**CITY OF DELAWARE  
PLANNING COMMISSION  
AGENDA**

## PLANNING COMMISSION/STAFF REPORT

CASE NUMBER: 2016-3559

PROJECT: Midway Structural Pipe and Supply Inc.

PRELIMINARY SITE PLAN

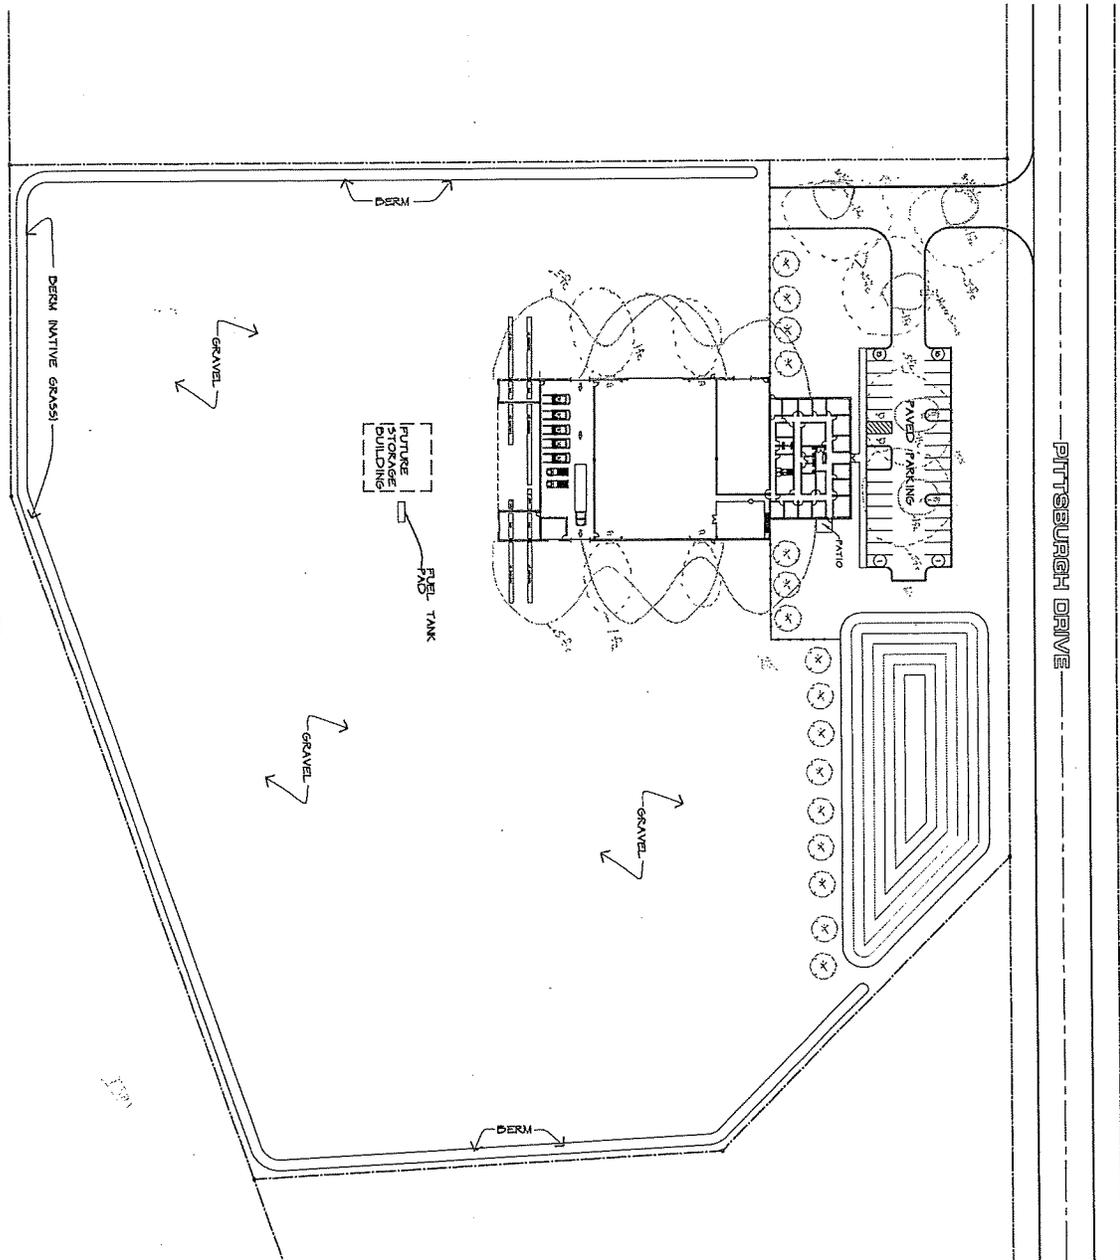
- **ROADS AND ACCESS:** The subject site has one full movement curb cut from Pittsburgh Drive. The access road would extend south through a secure gate to the large laydown area. Just east of the access road in front of the office portion of the building is a 31 space parking lot. The apron from Pittsburgh Drive would be concrete while the access road to the security gate and laydown would be constructed of asphalt milling which is a dustless surface as approved by the City Engineer in this application. The parking lot would be constructed of asphalt. Staff recommends the access drive from Pittsburgh Drive to the security gate separating the parking lot from the laydown area shall be constructed of asphalt. Also, the east end of the employee parking lot shall have a standard "T Turnaround" for emergency vehicles. The Fire Department wants to ensure the parking lot and the laydown area is accessible and has a clear path for all types of emergency vehicles.

- **SITE CONFIGURATION:** The proposed 29,480 square foot building with a 31 space parking lot fronts Pittsburgh Drive just east of the proposed curb cut. A fence with a security gate would separate the access drive, employee parking lot and office portion of the building from the warehouse portion of the building and the large laydown area which contain outside storage of steel pipe and other steel products associated with general fencing materials. Based on the proposed office (5,400/300 = 18 parking spaces) and warehouse (24,080/1000 = 25 parking spaces) square footage breakdown provided by the owner, 43 parking spaces would be required per the zoning code. However per Chapter 1161.08, the Planning Commission can grant a 30% reduction (43 x 0.70 = 31 total spaces) if the subject future spaces could be constructed on the site. The applicant is identifying 31 parking spaces while the site is large enough to accommodate the remaining 12

required spaces if the existing user or future user would have a parking issue and staff could require the appropriate parking spaces to be constructed. This would be consistent with past decisions for other industrial uses. There is no compelling reason to pave additional area for what would likely be a vacant parking spaces at this time. The critical element is that there is sufficient room and accesses to allow the future provision for additional parking should it become necessary either by the applicant or by the City. A fuel tank pad along with a future storage building would be located directly behind the warehouse portion of the building in the laydown area. In addition, a proposed three foot high mound with native grass would buffer the eastern, western and southern perimeters of the property. Also, a detention basin is located east of the building along Pittsburgh Drive.

2. The laydown area shall be an asphalt milling (or approved equivalent) application which is a dustless surface approved by the City Engineer in this specific case.

3. The access drive from Pittsburgh Drive to the security gate shall be constructed of asphalt (less the concrete apron).
4. The east end of the employee parking lot shall have a standard "T Turnaround" for emergency vehicles.

5. The parking lot shall contain a minimum 31 parking spaces.
6. All building appurtenances (coping, downspouts, etc.) shall be painted to match the adjacent building color.

**EXTERIOR ELEVATIONS**

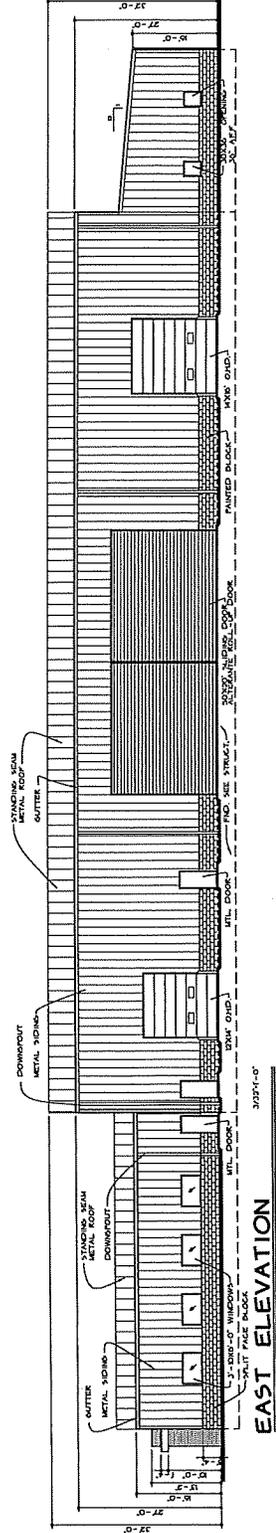
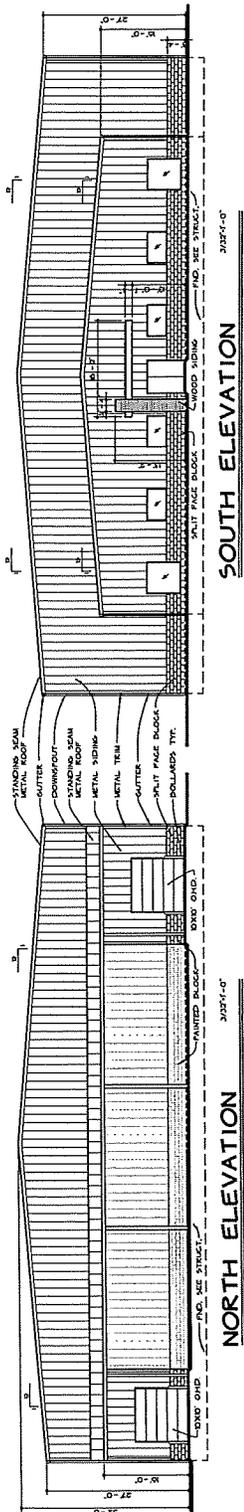
- **BUILDING DESIGN:** The proposed office portion of the building would be 19.9 feet high while the warehouse portion of the building would be 32 feet high. The building elevation would be comprised of grey metal panels with a lighter grey split face block wainscoting around the office building and regular block wainscoting extending around the warehouse portion of the building. The main entrance into the office would be on the north elevation with six windows, a man door and two windows would be on the north elevation and a man door and four windows would be on the west elevation. The south elevation of the warehouse would have two overhead doors, the east elevation would have two overhead doors, two man doors and five windows and the west elevation would have four overhead doors, three man doors and two windows. All building appurtenances (coping, downspouts, etc.) shall be painted to match the adjacent building color.
